April 7, 2021

RE: Notice of Intent – Response to Commission’s Comments
0 Hudson Street, Northborough, MA

The Commission’s Comments with Norse Environmental Services Responses

Mitigation Planting Plan

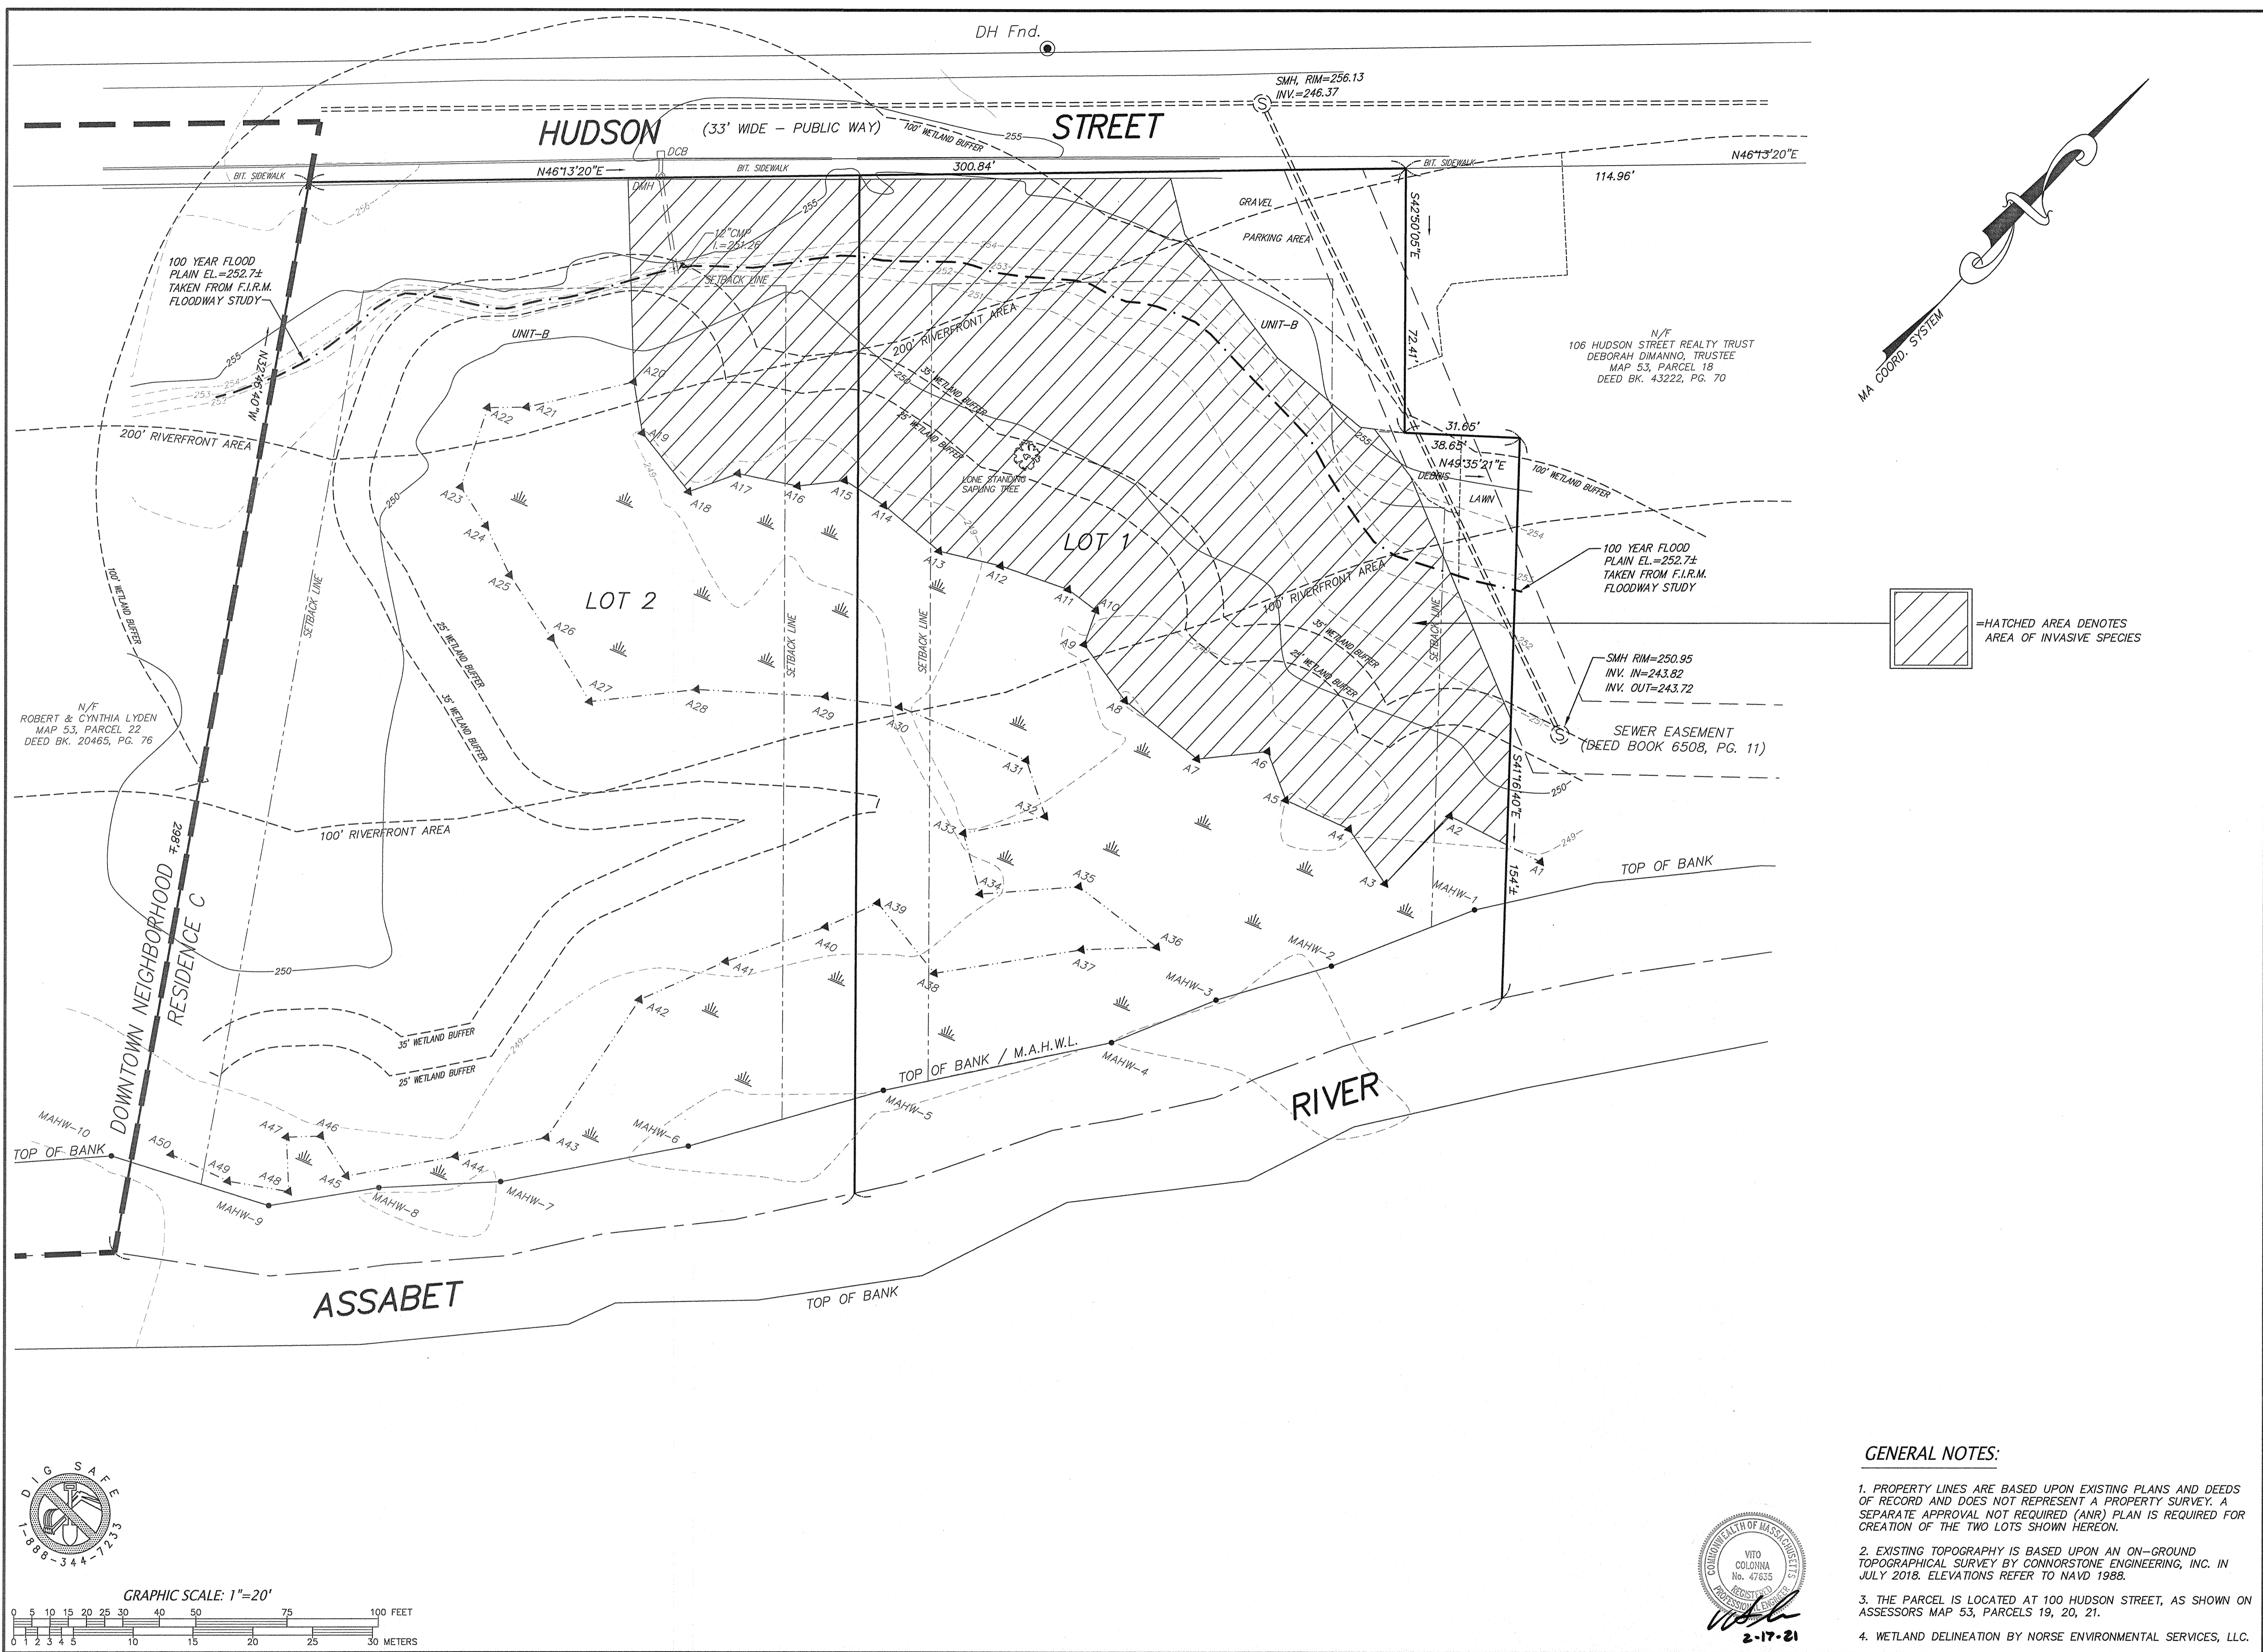
Compensatory storage/restoration of the inner riparian zone: please provide a schematic of the planting plan to confirm adequate spacing and coverage. Staff recommends the addition of permanent markers along the fenced retaining wall and street or some alternative to prevent future encroachment.

A planting plan for the compensatory storage /restoration of the riparian zone has been provided as an attachment to this report (see the *Mitigation Planting Plan*, dated 4/7/2021, for details). Permanent markers along the fenced retaining wall and street will be provided to prevent future encroachment (shown on the site plans). The fence along the retaining wall will act as physical barrier. Signage will be installed on the fence to reduce the risk of future encroachment. Individual signs will be posted along the street.

1.5:1 RIP RAP SLOPE SCHEMATIC

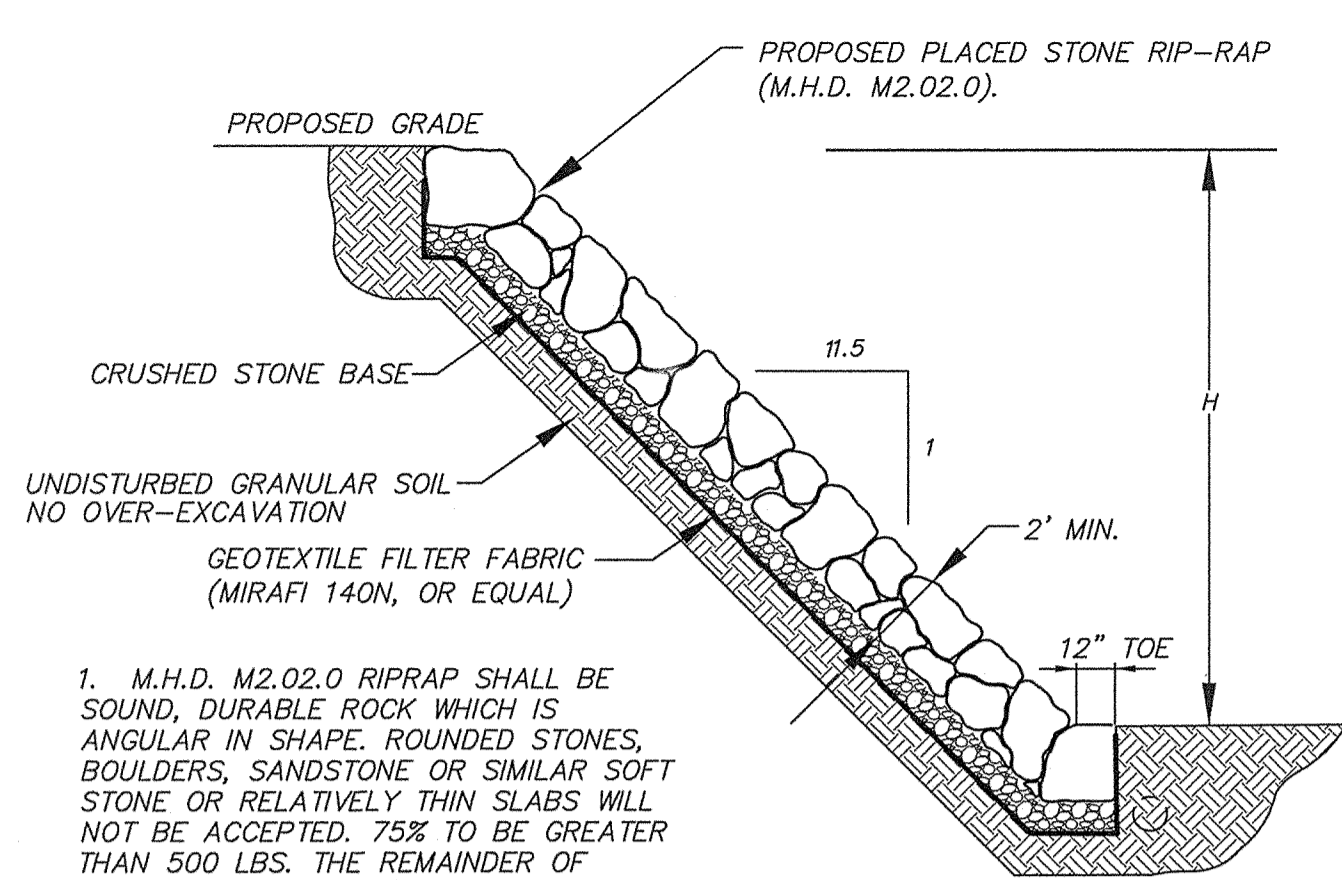
The 1.5:1 stabilized slope requires a detail for slope stabilization. The Commission requires slope reinforcement designed by registered, professional civil or geotechnical engineer licensed in the state of MA for slopes greater than 3:1.

A detail for slope stabilization has been added on the Site Plans (see sheet 3 of 3, revision date 2/17/2021). The detail is labeled, "1.5:1 Rip Rap Slope Schematic".
